Revision Description	Date	Rev. No.	Issued by
LRD Amendment Application	09-10-2026	A3-C01	MM

Project: Player Wills
Location: Former Player Wills Site, South Circular Road, Dublin 8
Client: CWTC Multi Family ICAV

Drawing Title: PW2 - Proposed Level 16 Plan
Drawing No.: 25068-OMP-PW2-16-DR-A-1016

PW2 - Proposed Level 16 Plan

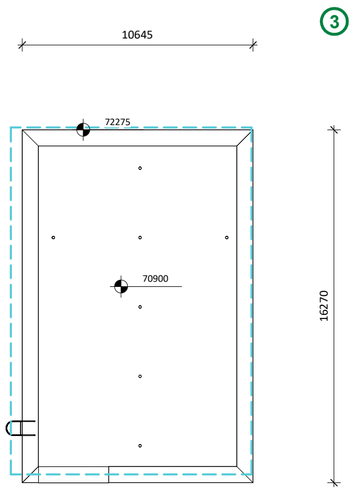
1. Provision of a second stair in accordance with updated Building Regulations (TGD Part B), with associated reconfiguration of layouts.
2. 2-bed changed to 1-bed to facilitate requirement for second stair to comply with new fire regulations
3. Permitted 1-bed duplex unit is reconfigured as 1-bedroom apartment.
